AW: Replacement capacitor

Just going back to this issue about the failing gold cap capacitors on the Ceratherm 600-3.

Super Capacitor (C16 on CPU-Board)

Table 1 – Ratings & Part Number Reference

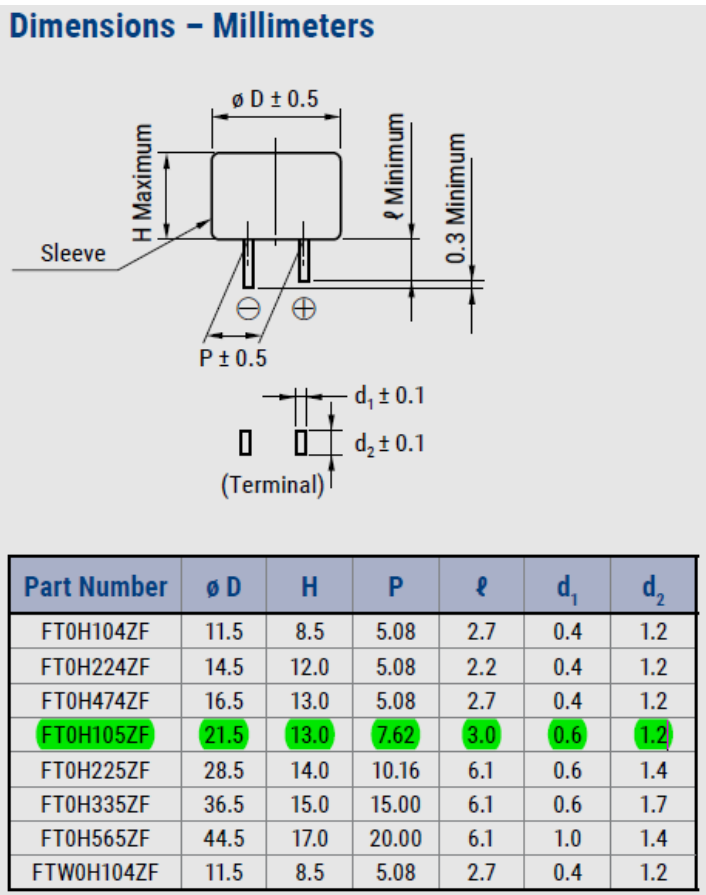
A Medical Engineering Department in one of our hospitals has sourced a suitable looking capacitor, they successfully performed a repair using this. I just wanted to check with you whether it looks suitable.

Please can you review the attached data sheets and advise?

The product is basically suitable. The requirement criteria are fulfilled. Regarding capacity (1.0 F) and the connection pitch (7.5mm), this type would have to be selected:

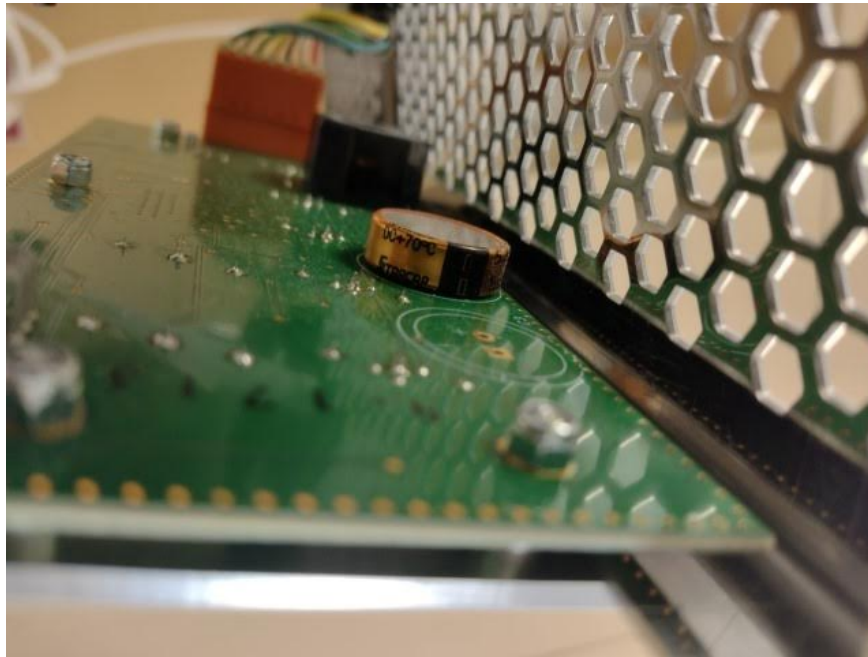
All 6 devices failed to meet the requirement of the power disconnect alarm sounding for 10 minutes without power.

I assume that replacing the controller PCB will resolve this issue, but that is a very expensive fix. Is there a simple solution?

Looking at the PCB, we can see that there is a capacitor on there. I don't have a wiring diagram but it seems very likely that this capacitor could be storing the charge to maintain the alarm in the event of a power failure.

Would a simple replacement of this capacitor fix the problem? And if so, do you supply it or can you give me the capacitor specification so that we can try it?

However, the customer can replace the energy storage device (super capacitor) if necessary. This component can be procured on the market (available from various manufacturers) and must comply with the following specifications:

Capacity: **1.0 F**
Dielectric strength: **5.5 V**
Temperature range: **85 °C**

Pitch: **7.5 mm**
Diameter: 20mm (other dimensions possible)
Height: 11mm (other dimensions possible)

Yes, you are right. This capacitor is responsible for maintaining the alarm in the event of a power failure.
